ADDENDUM NO. 1 - OUTLINE AND SUMMARY INFORMATION

Project Name: Grant Street Pedestrian Mall PPA No.: 22-0001
Location: Grant Street from 7th Ave to 11th Ave Date: 4/23/2024

SHEET
E1.5

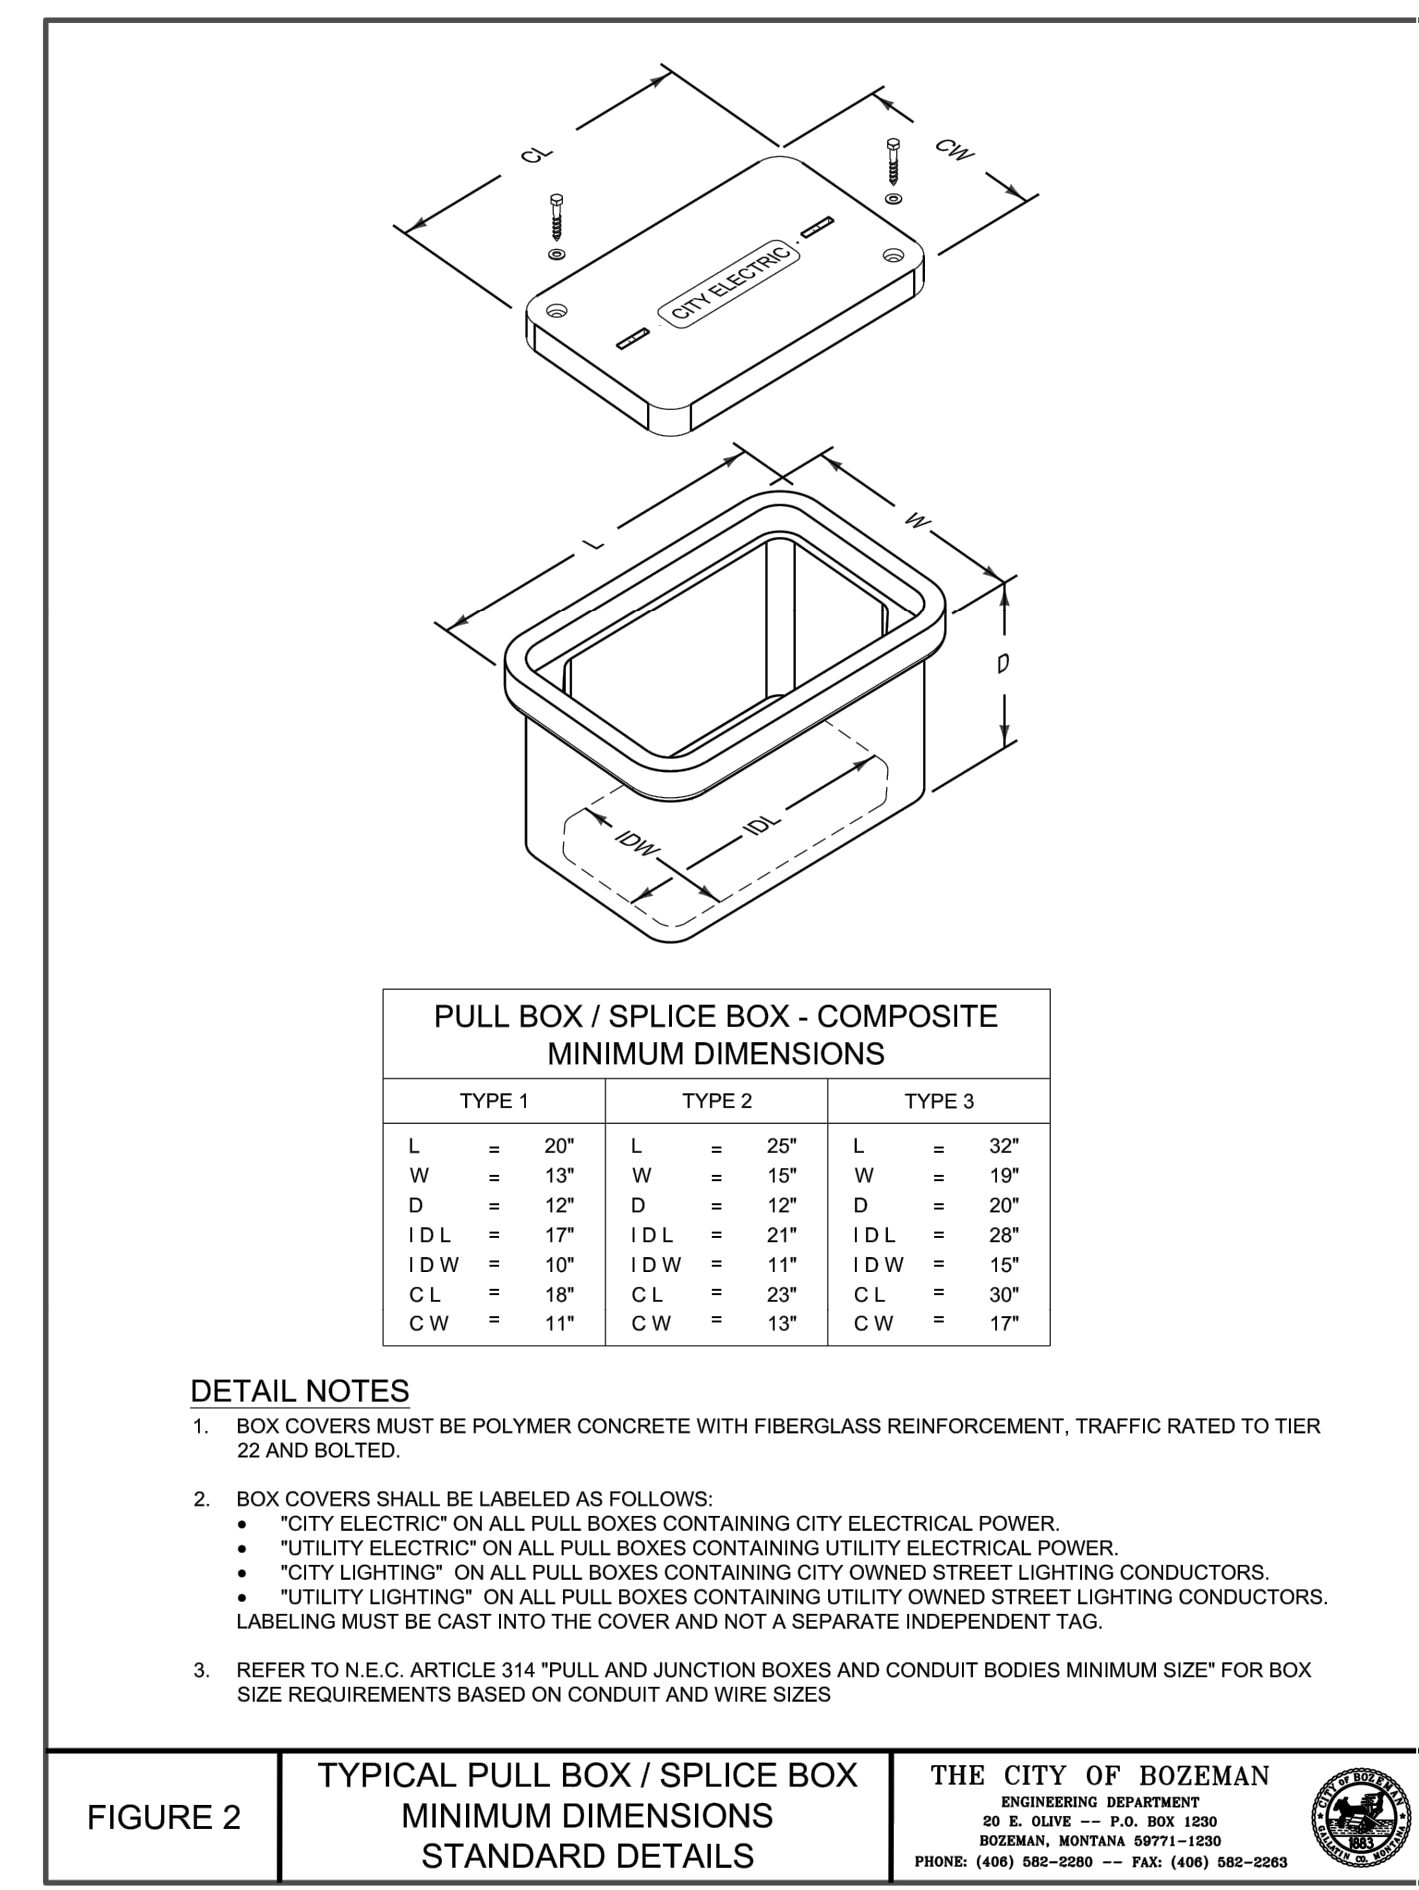
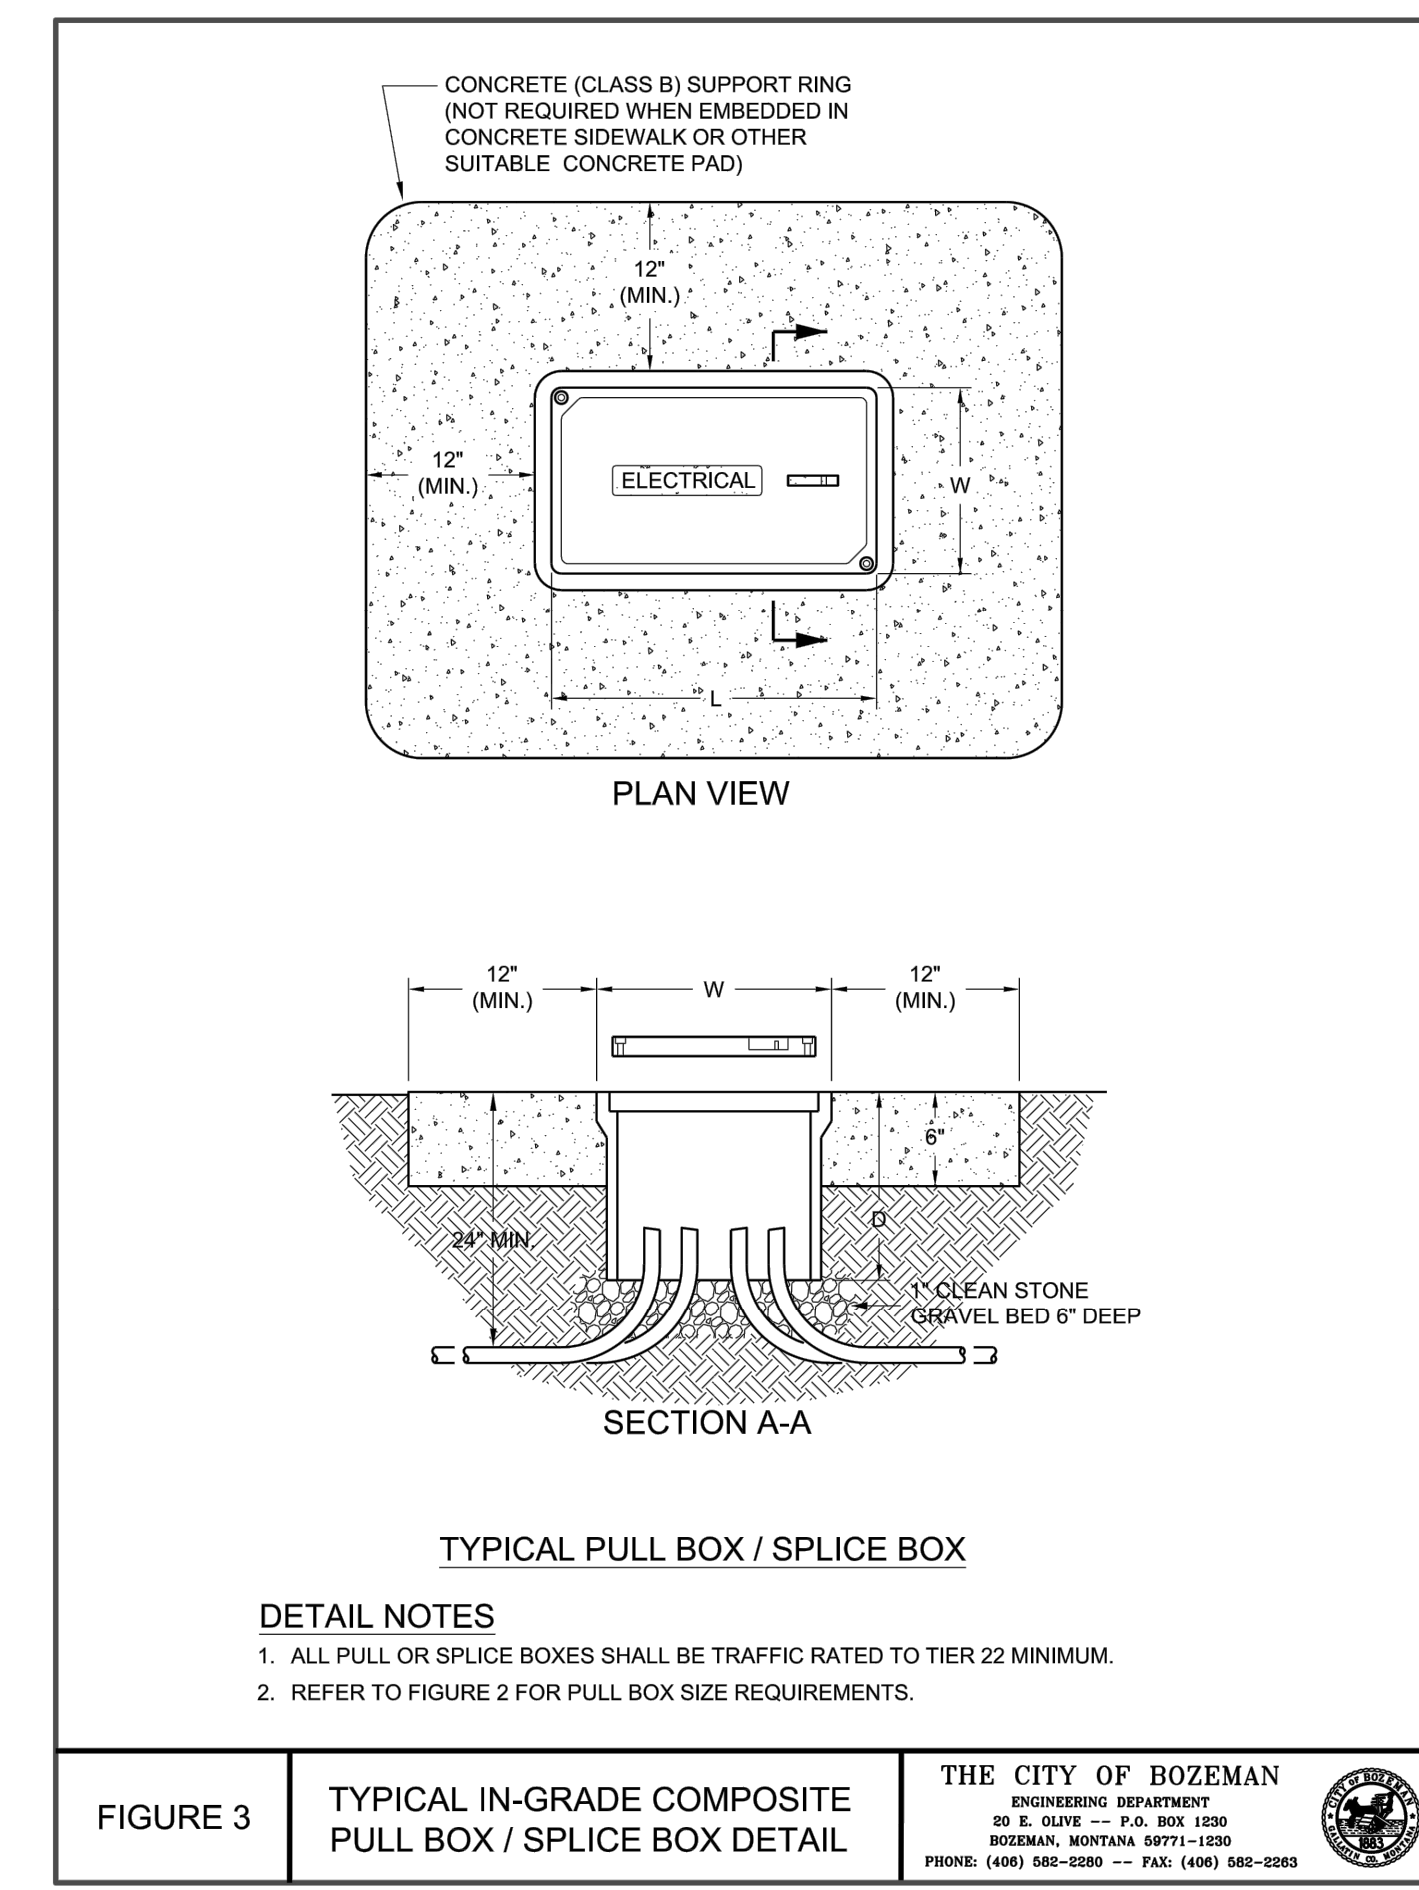
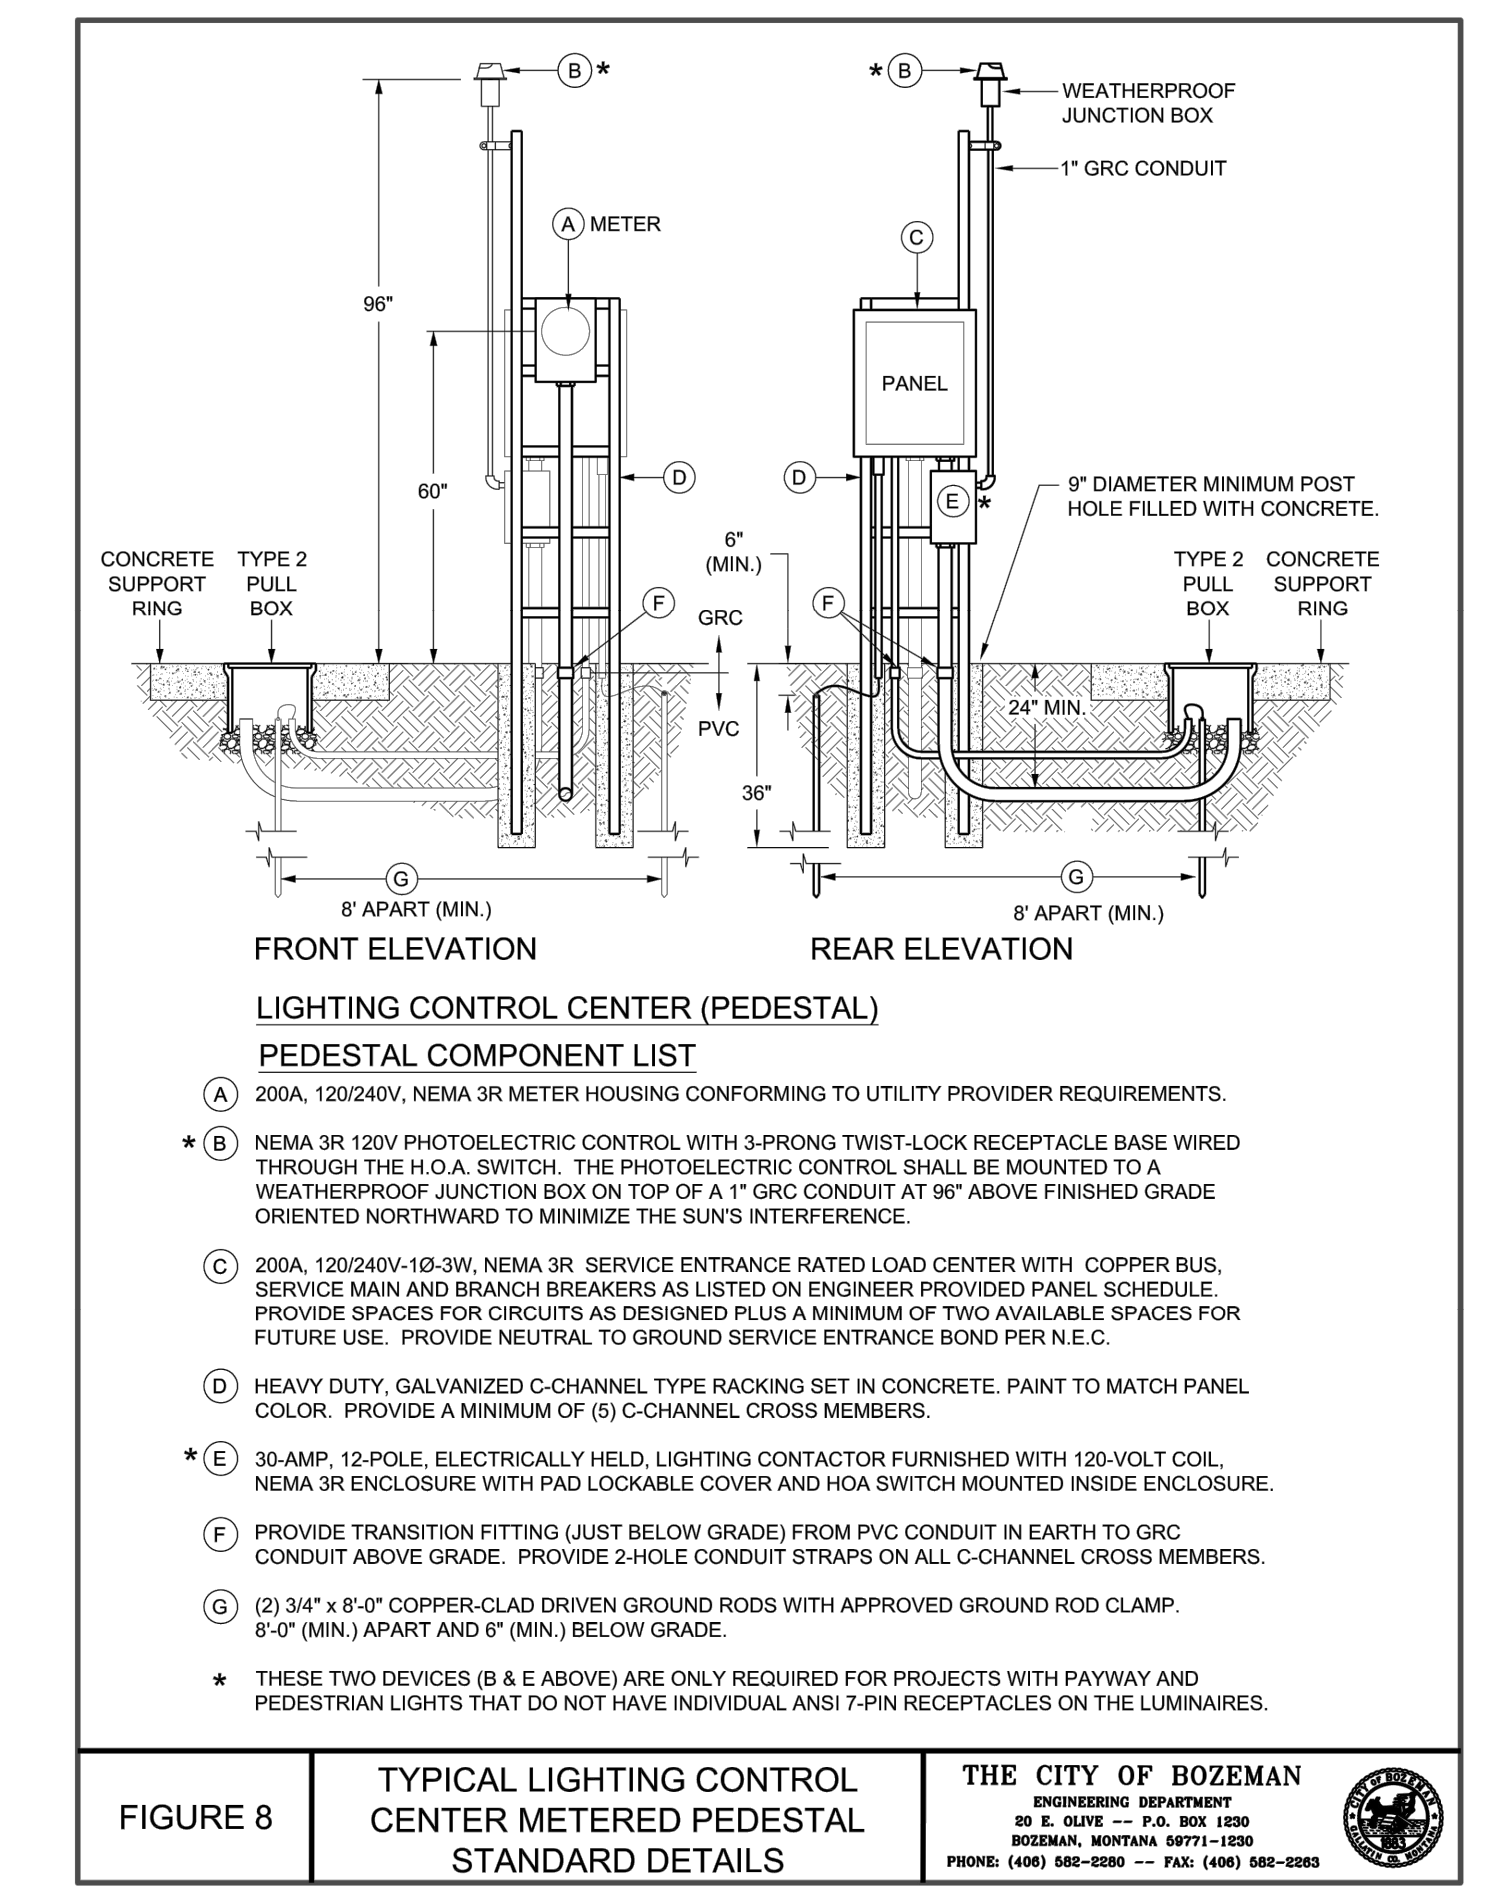
- D. Parking lot luminaires have been modified with new locations and two new units.
- E. Luminaire types and locations have been modified for crosswalk between SUB parking lot and roundabout.
- F. Luminaire types have changed around roundabout and along N 7th Avenue.
- G. Note 5 has been revised to state that existing conduit can be abandoned in place if not in conflict with other project elements. Wiring shall be pulled back to source, but conduit can be abandoned.
- H. Light fixture schedule has been updated to provide new model numbers including the FAWS, Pole Top fitters, TLRD7, CRI 80, fuses in-pole bases per latest edition of MSU Engineering Guidelines.
- I. Details have been added for pull boxes and the electrical service drop.
